Re: Minor Project Refinement No. 17 for the South Orange County Reliability Enhancement Project.

South Orange County Reliability Enhancement Project CPUC Minor Project Refinement Form

Report No.: 17

MPR-17 Figure 1

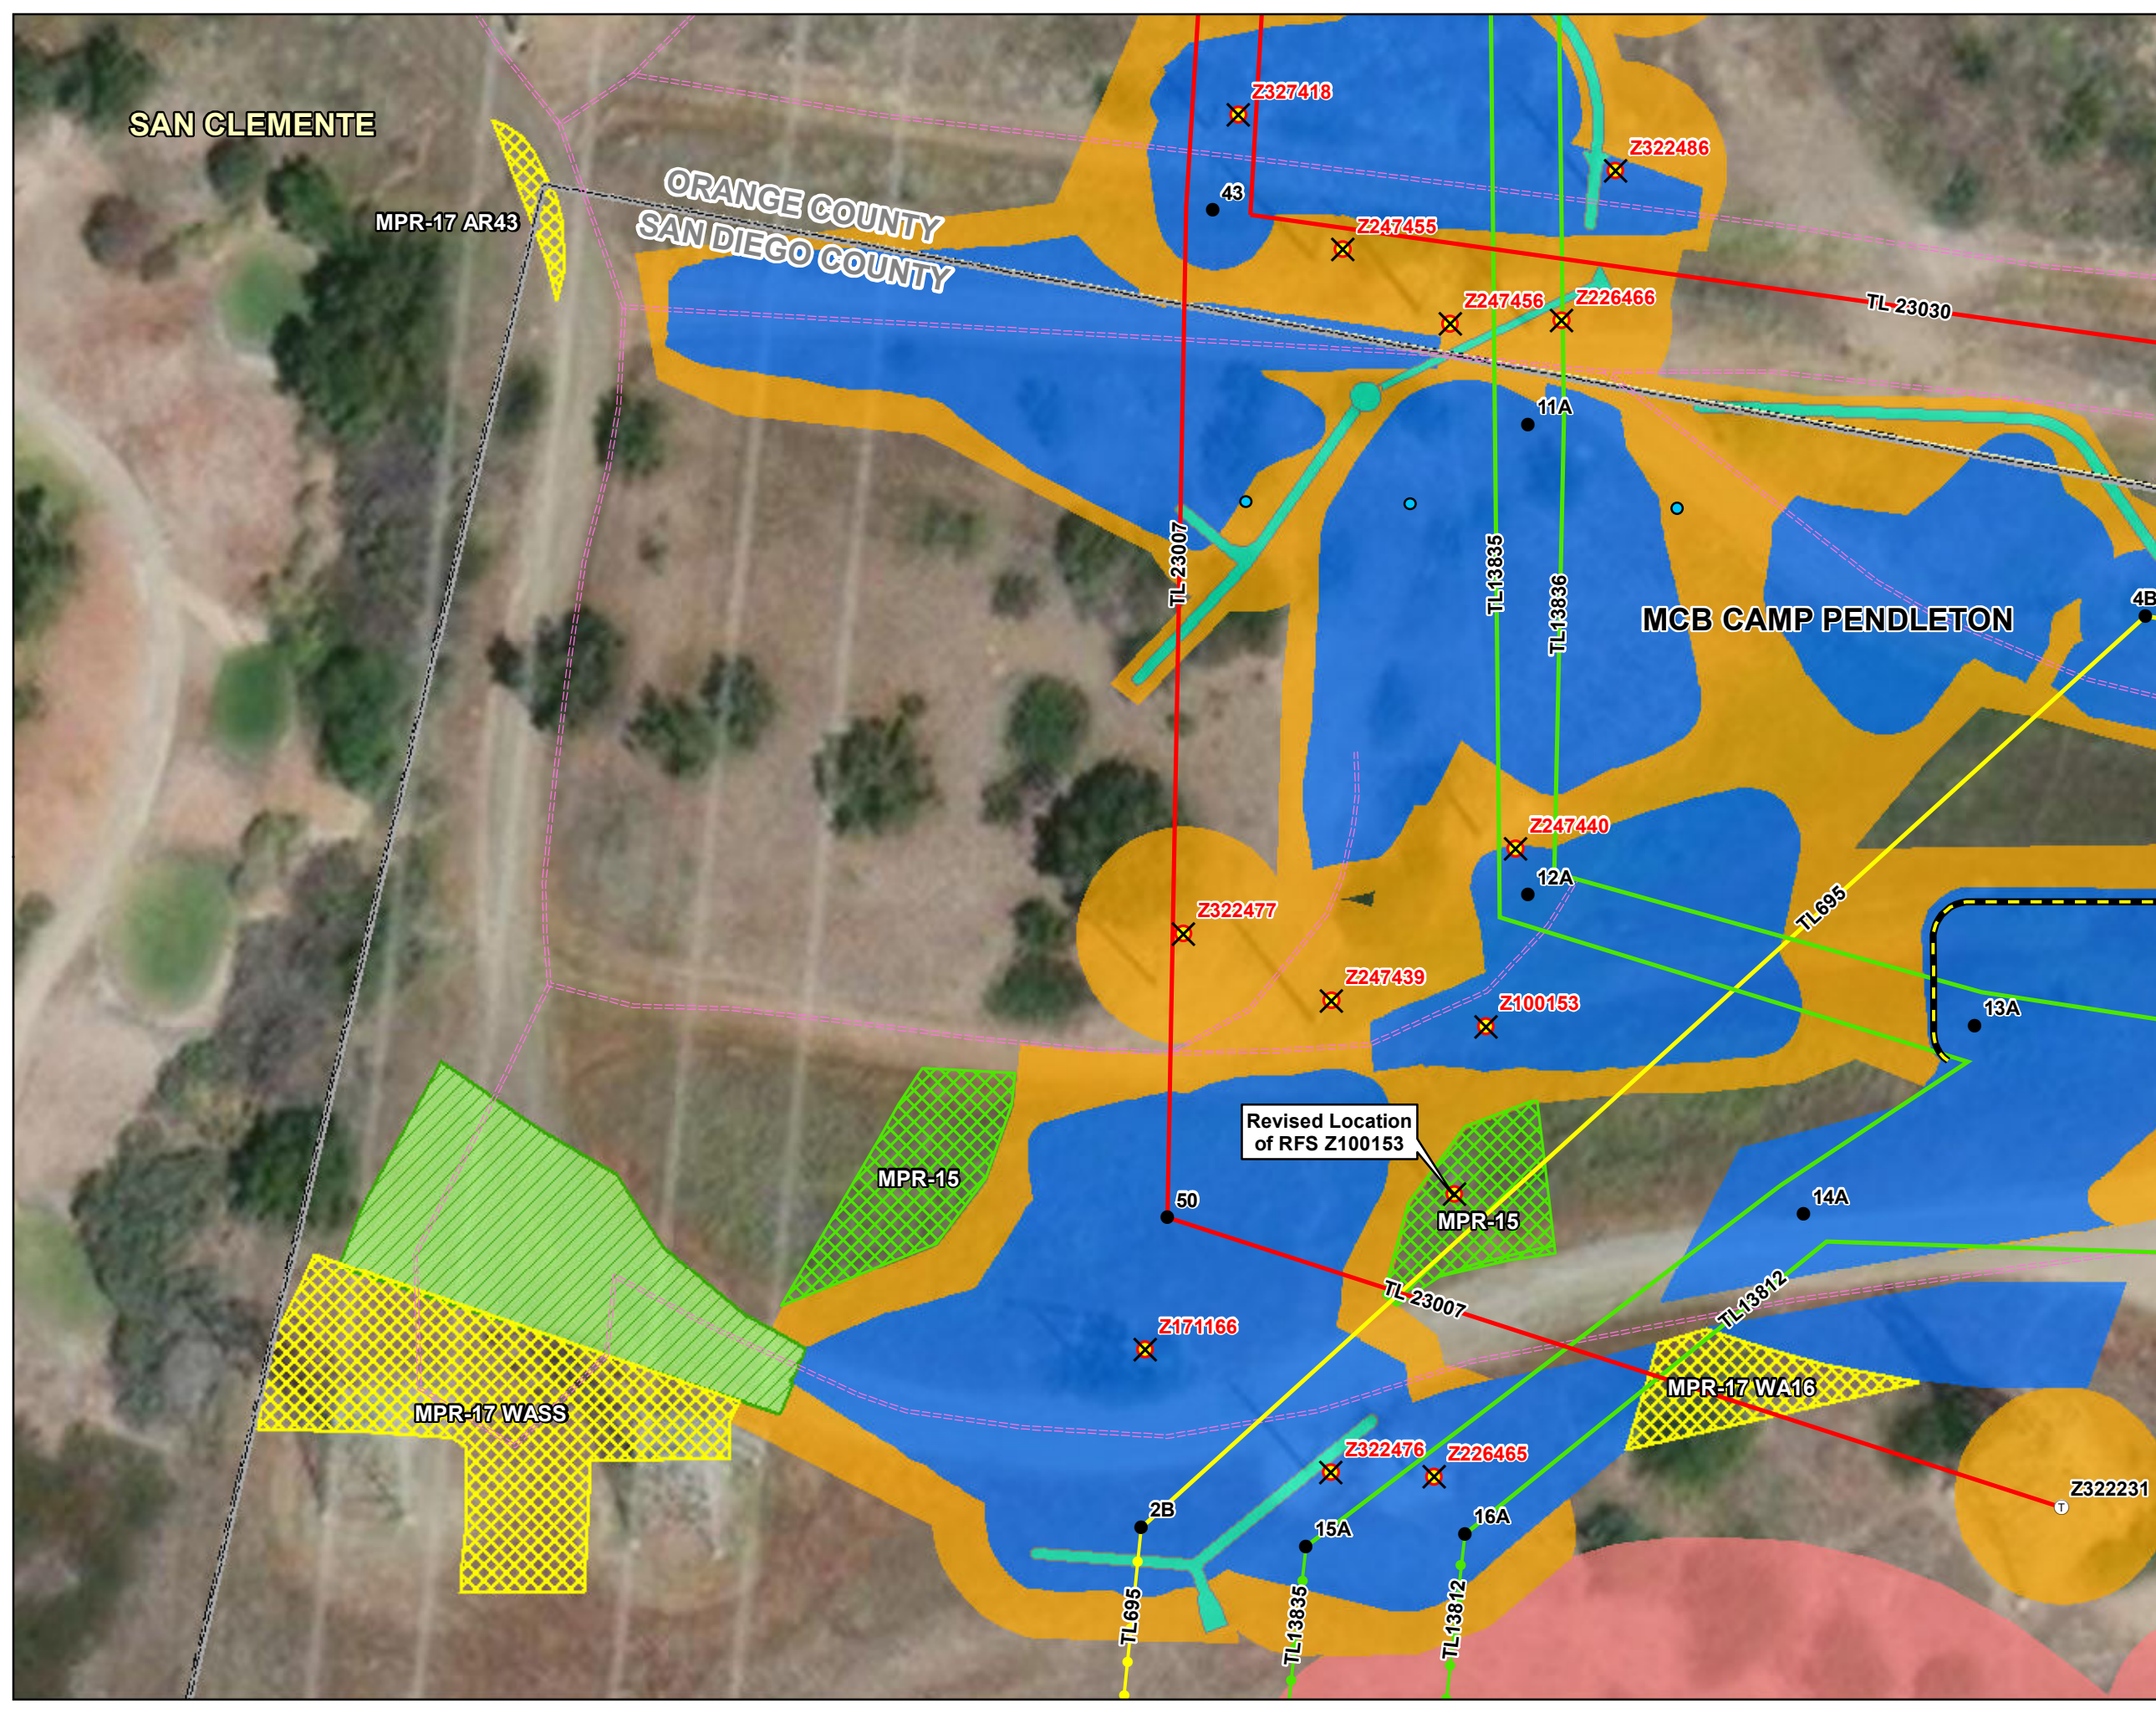
San Diego Gas and Electric (SDG&E) is requesting approval of MPR-17 for three new temporary work areas for the South Orange County Reliability Enhancement Project (SOCRE or Project). The new temporary work areas are contiguous with previously approved project components as shown in **Attachment B, MPR-17 Figure**. The new MPR-17 work areas will total approximately 6,380 square feet (0.15 acre).

The WASS and WA16 temporary work areas will be utilized for safe temporary laydown of corrugated metal pipes (CMP) for NTP-7 transmission line construction activities. No ground disturbance is anticipated. Cribbing within the WASS and WA16 temporary work areas will be placed to accommodate construction equipment as needed. Trimming (mowing) will be required for disturbed vegetation within the work areas.

The AR43 temporary work area contains a non-functioning fence post that is currently inhibiting the ability to deliver CMPs to the necessary work areas. The fence post will be cut flush with the ground and no ground disturbance is anticipated. AR43 activities will include mowing vegetation for fence post removal and fire mitigation. **Attachment B, MPR-17 Figure** shows the locations of the MPR-17 temporary work areas.

Although the proposed MPR-17 temporary work areas total 6,380 square feet (0.15 acre), a large portion of the previously approved work area contiguous to the Location 50, 2B, 15A, and 16A work areas is no longer being utilized by the Project (see **Attachment B, MPR-17 Figure**). This southern portion of the work area originally totaled 14,300 square feet (0.32 acre) in temporary impacts. MPR-15 approved 2,925 square feet (0.07 acre) of temporary impacts within the same contiguous work area and MPR-17 is proposing 6,380 square feet of impacts (0.15 acre). Therefore, the overall temporary disturbance acreage would not be increased by the addition of the MPR-17 temporary work areas. The overall temporary disturbance area would still be approximately 4,995 square feet (0.11 acre) less than what was approved in NTP-7 and the Amended REIR document.
